Scientific Notebook No. 506: Review of DOE
Subsurface ventilation Analysis/Design
(03/14/2002 through 05/20/2005)

Ventilation Review

The principal investigator of this activity is Troy Maxwell. The objective of the activity is to review DOE subsurface ventilation reports.

Objective: To model the subsurface ventilation system of Yucca Mountain to confirm the analysis or results of analysis in DOE reports.

Scenario I (friction factor: $0.004 \text{ N s}^2/\text{m}^8$)

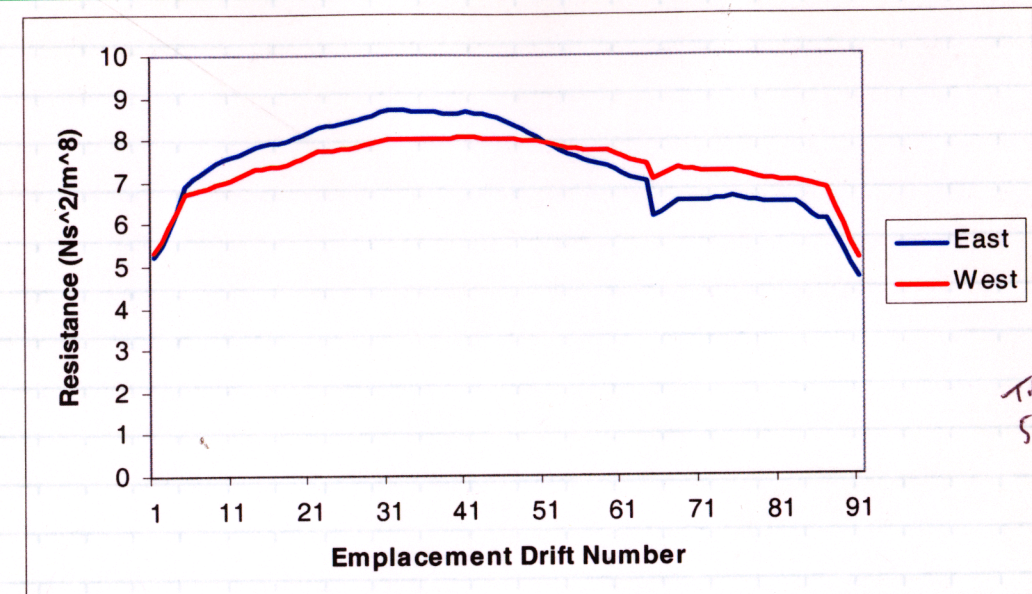
As stated from the above entry, the added resistance from the software with the fixed quantity feature simulates the effect the louvers will have on the system. Scenario I from page 6 of this notebook was run and the results were plotted in Excel. The added resistance is called the Regulator Resistance given in the fixed quantities window of Vnet. The Regulator Resistance was plot for the east and west main for each emplacement drift. The plot illustrates the system had an ample amount of air flow to pull $15 \text{ m}^3/\text{s}$ in each emplacement drift. If any emplacement drift reads close to zero for the Regulator Resistance, that drift is not receiving enough air pressure from the east or west main. Hence the fan pressure would need to be increased or the friction factor lowered.

Scenario II (friction factor: $0.017 \text{ Ns}^2/\text{m}^8$)

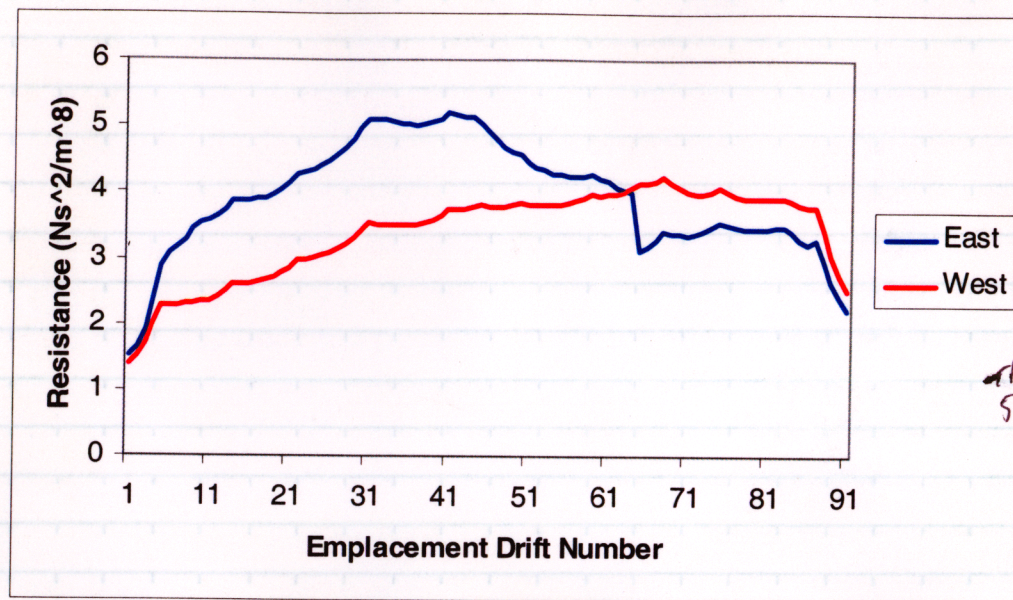
Scenario II was run and plotted into Excel. The plot illustrates the system is still able to pull enough air to meet the $15 \text{ m}^3/\text{s}$ criteria for each emplacement drift. The Regulator Resistance is getting lower hence the pressure in the east and west mains is lower for a higher friction factor which is expected. Both show a drop near the 60th emplacement drift. This is due to the gap in the footprint illustrated on page 7 of this notebook. Also the east side of the emplacement drift is receiving more air than the west illustrated by the higher Regulator Resistance of the east side. This is because the west side emplacement drifts are longer than the east side requiring more air from the west main. Therefore the thinner the air in the west main, the lower the Regulator Resistance for the west side of the emplacement drifts.

Scenario III (friction factor: $0.028 \text{ Ns}^2/\text{m}^8$)

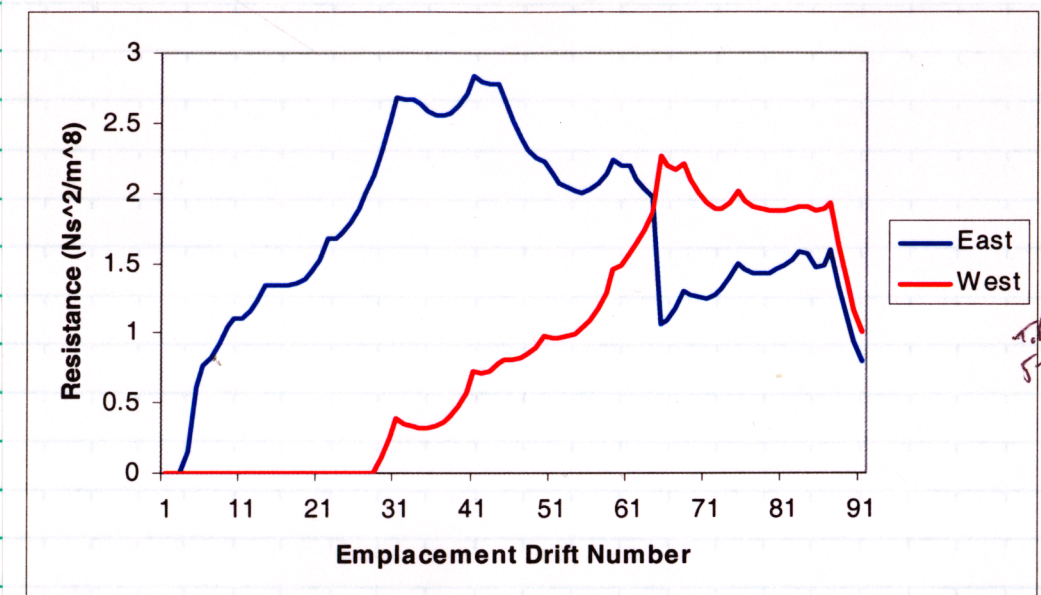
Scenario III was run and plotted into Excel. The results are consistent with Scenario II that the Regulator Resistance is dropping with the higher friction factor. The system was unable to pull $15 \text{ m}^3/\text{s}$ in each emplacement drift at this friction factor. The friction factor in each of the three Scenarios was applied to each branch in the model. For example, for Scenario I, a $0.004 \text{ Ns}^2/\text{m}^8$ friction factor was applied to every branch in the model. In reality the branches would not have the same friction factor. The emplacement drifts should be expected to have a higher friction factor with the waste packages and drip shield. However, the fixed quantities function of Vnet software makes this irrelevant. When a drift (branch) is set to $15 \text{ m}^3/\text{s}$ the software pulls $15 \text{ m}^3/\text{s}$ independent of what the resistance of that branch may be. Hence the plots would not change if the system friction factor was set to $0.004 \text{ Ns}^2/\text{m}^8$ and the emplacement drift friction factor was set to $0.5 \text{ Ns}^2/\text{m}^8$. The Regulator Resistance is the resistance the software adds to the branch to keep the flow rate from going above $15 \text{ m}^3/\text{s}$. The plots illustrate if the system is able to get enough air to each emplacement drift

to pull $15 \text{ m}^3/\text{s}$ but does not demonstrate what happens to the air flow in the drift.

Average Velocity (Scenario I, II and III)

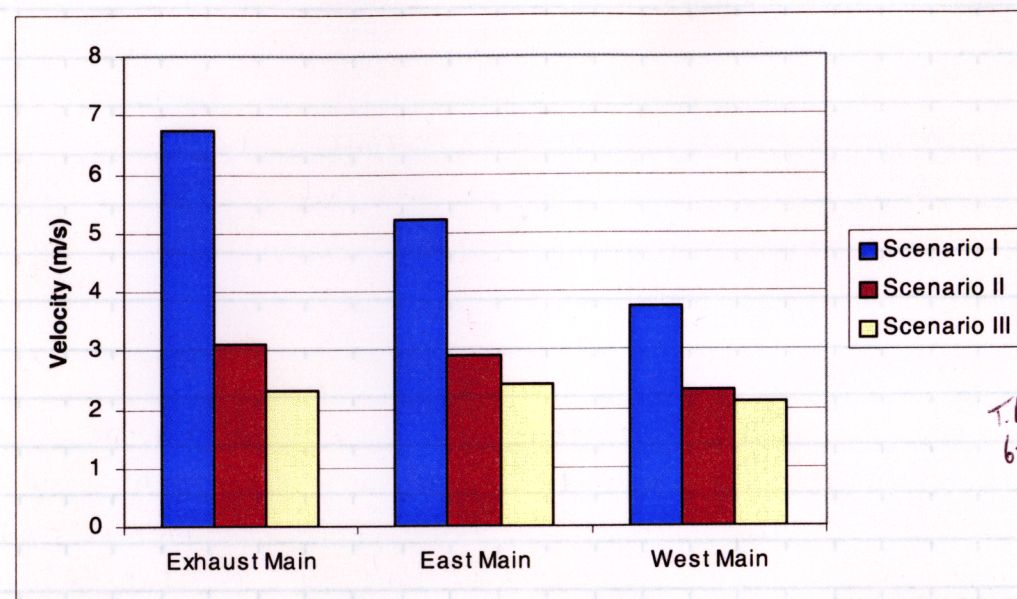
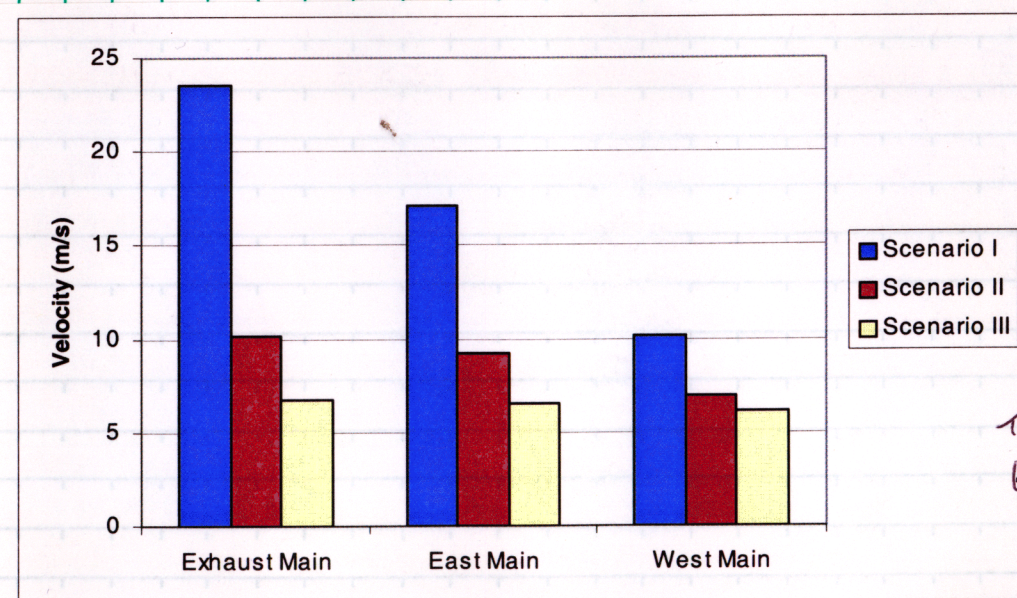
The three Scenarios were also plotted in the form of maximum and average velocity for the exhaust main, west main and east main. From the branch results window, the airflow in each branch was divided by the area of that branch. In "Overall Subsurface Ventilation System" the air velocity is not expected to exceed 8 m/s which is listed as a maximum recommended value for smooth lined drifts in section 6.4.1. The exhaust main displayed the highest velocity which is expected since it is receiving large volumes of air from the east and west main. The east and west main averaged between 2 and 3 m/s (≈ 5 to 7 mi/hr) with the maximum between 5 and 10 m/s ($\approx 11 \text{ mi/hr}$ to 22 mi/hr).
